Dart Aerospace Ltd. Friday, 8/3/2007 1:59:34 PM Jean-Luc Menard **Process Sheet** : ACCESS PANEL ASSEMBLY Customer : CU-DAR001 Dart Helicopters Services **Drawing Name** Job Number : 33830 **Estimate Number** : 12546 : 41A: : D3256041 Part Number P.O. Number S.O. No. : HA · D3256 REV B : 8/3/2007 This Issue **Drawing Number** : N/A Prsht Rev. : NC Project Number : NA : SMALL /MED FAB First Issue **Drawing Revision** · NIA : 33475 Material Previous Run : 8/10/2007 **Due Date** Written By Checked & Approved By Comment New-Issue 06-10-03 JLM : Est Rev:A Additional Product Job Number: Description: Seq. #: Machine Or Operation: 1.0 304/316 .032 Sheet M304S22GA Comment: Qty.: 0.9870 sf(s)/Unit Total: 0.9870 sf(s) 304/316 .032 Sheet CAD WATER JET (Machine File D3256- | No Holes mment: FLOW WATER JET 1-Cut as per Dwg D3256 Prog Rev: 2-Deburr if necessary INSPECT PARTS AS THEY COME OFF MACHIN 3.0 QC2 Comment: INSPECT PARTS AS THEY COME OFF MACHINE SAD 4.0 SECOND CHECK Comment: SECOND CHECK

DESIGN RF	DRAWN BY RF	DART AEROSPACE HAWKESBURY, ONTARIO, CAN		***************************************	سجب
CHECKED ,,	APPROVED //	DRAWING NO.		REV.	В
-	- At	D3256	SHEET	2 OF	3
DATE		TITLE		SCA	LE
05.06.2

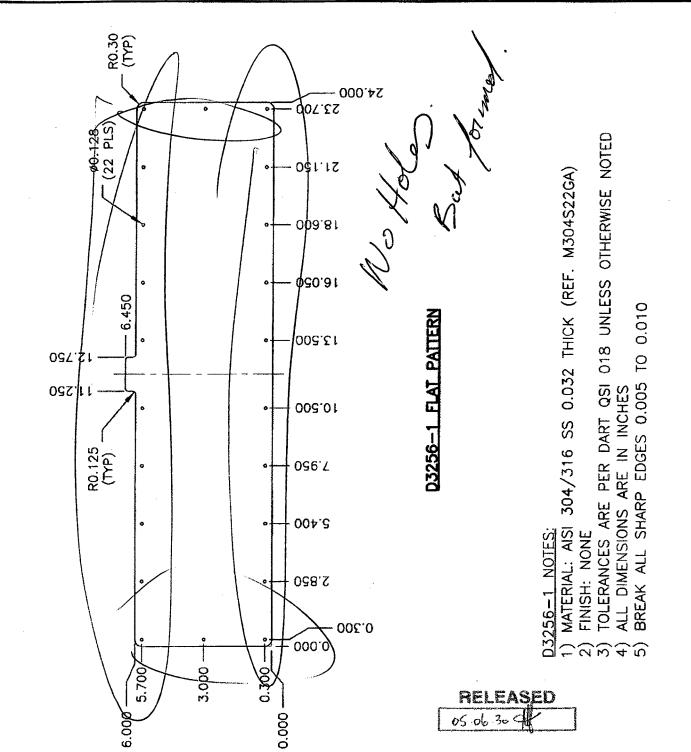
For some reason there bolt pattern is slightly different from the standard so we need to send them:

(1) One times D3256-3 Gasket Steck

(2) One times D3256-041 Access Panel WITHOUT THE GASKET INSTALLED AND WITHOUT ANY HOLES – the panel will still be bent and formed as per dwg
